October 16, 1984

Docket Nos. 50-259/260/296

The Commission has issued the enclosed Amendment Nos. 114, 108 and 82 to Facility Operating License Nos. DPR-33, DPR-52 and DPR-68 for the Browns Ferry Nuclear Plant, Units 1, 2 and 3. These amendments are in response to your application dated April 30, 1982 (TVA BFNP TS 173) and supplemented by a letter dated June 10, 1982.

BROWNS FERRY NUCLEAR PLANT, UNITS 1, 2 AND 3

Fig. 4.2-1

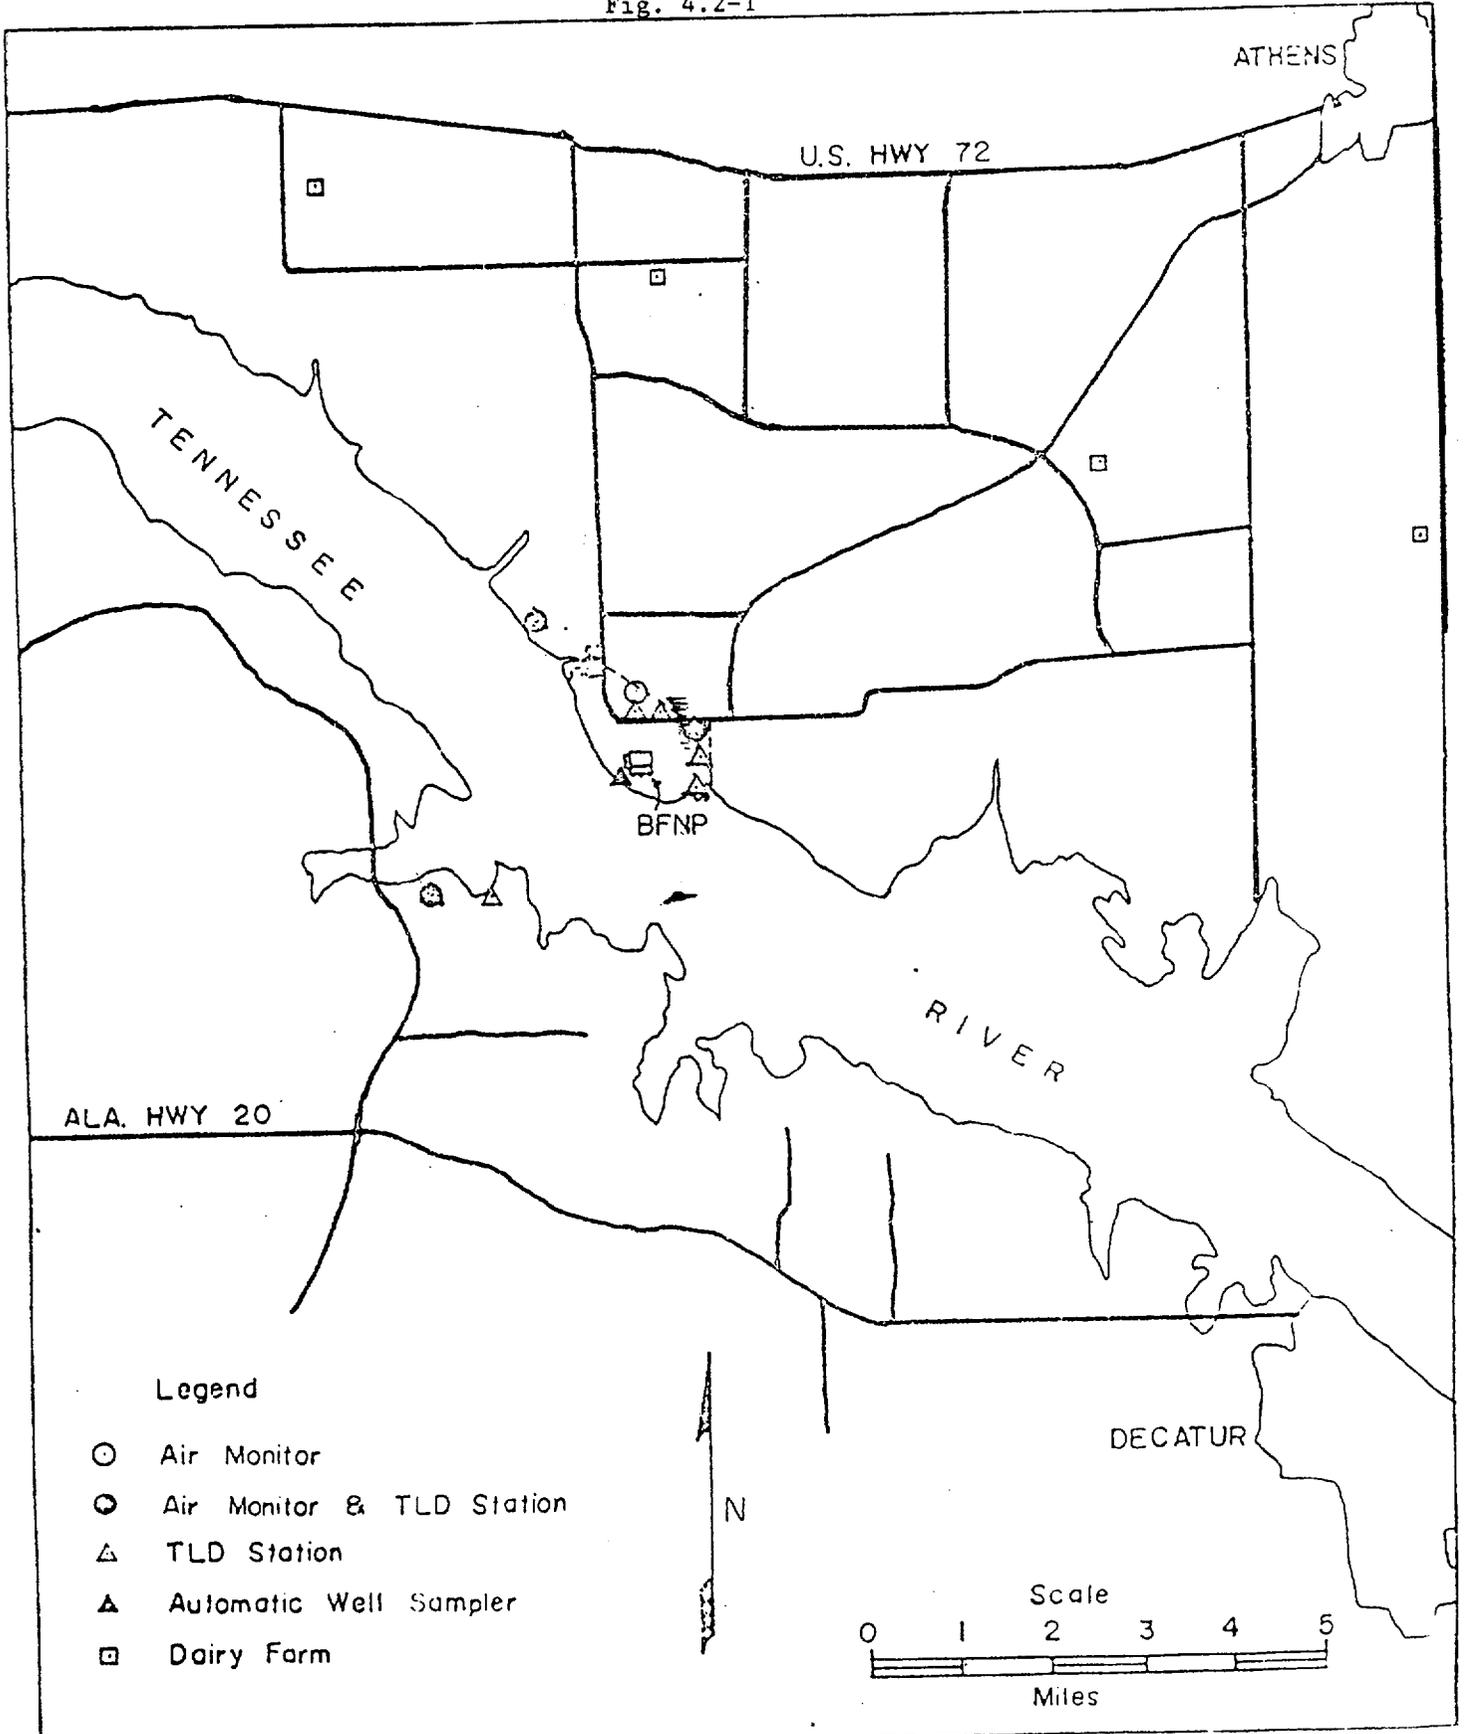
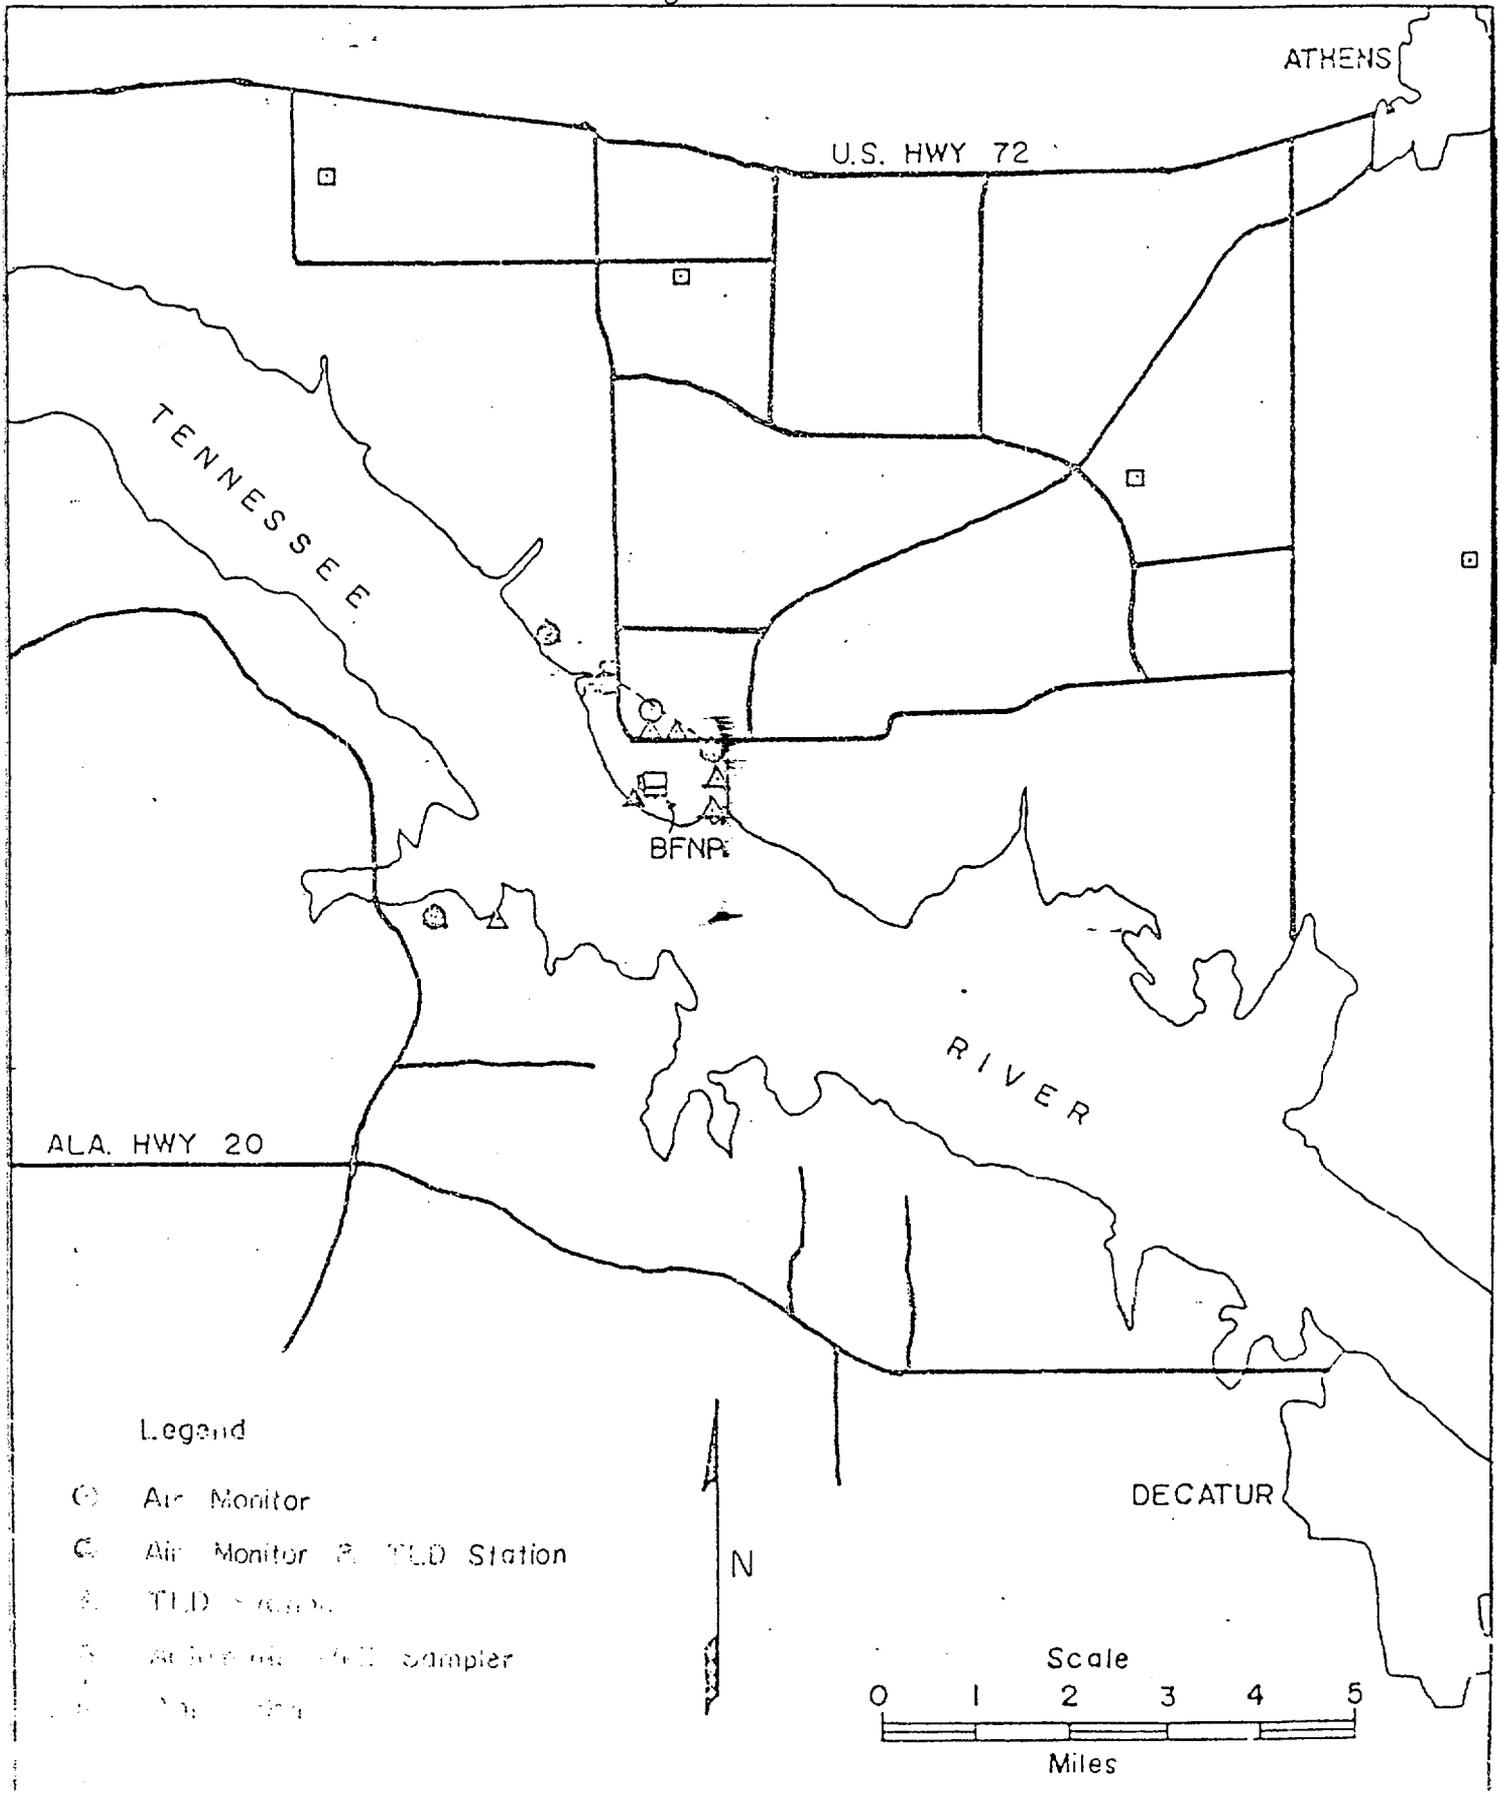
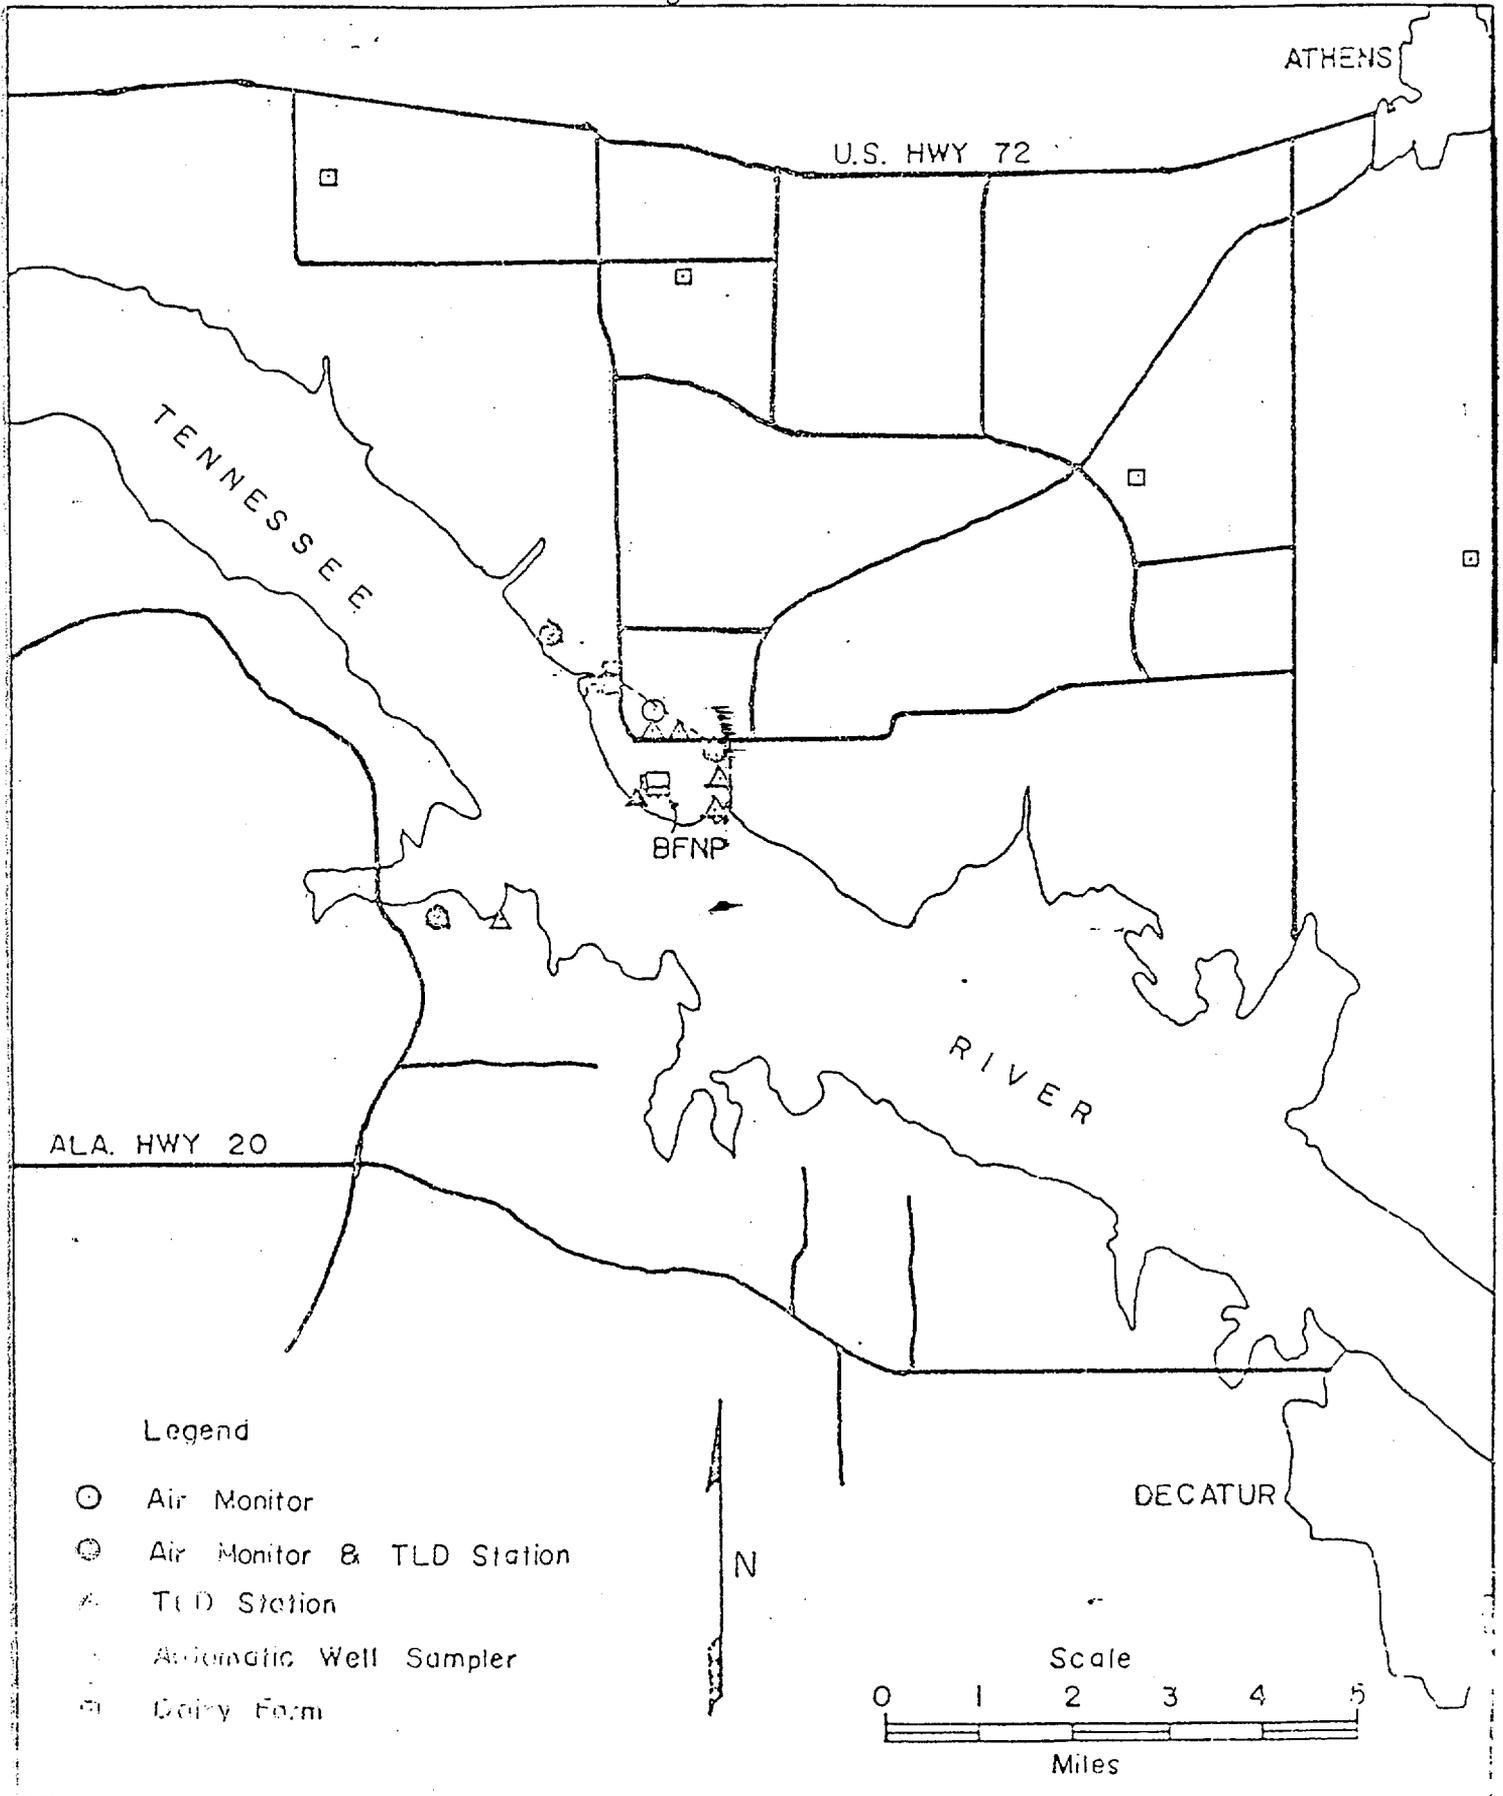
Environmental Technical Specifications (Appendix B) Paragraph 4.2.3.b requires that "milk shall be collected monthly when animals are off pasture, from at least four farms in the vicinity of the plant and analyzed as indicated in Table 4.2-1 and figure 4.2-1." Figure 4.2-1 depicts five dairy farms.

The licensee has requested a change to the figure deleting two of the dairy farms and adding a new one, stating that the two deleted sampling points no longer have milk producing animals. This change is acceptable based on the need to have four locations with milk producing animals.
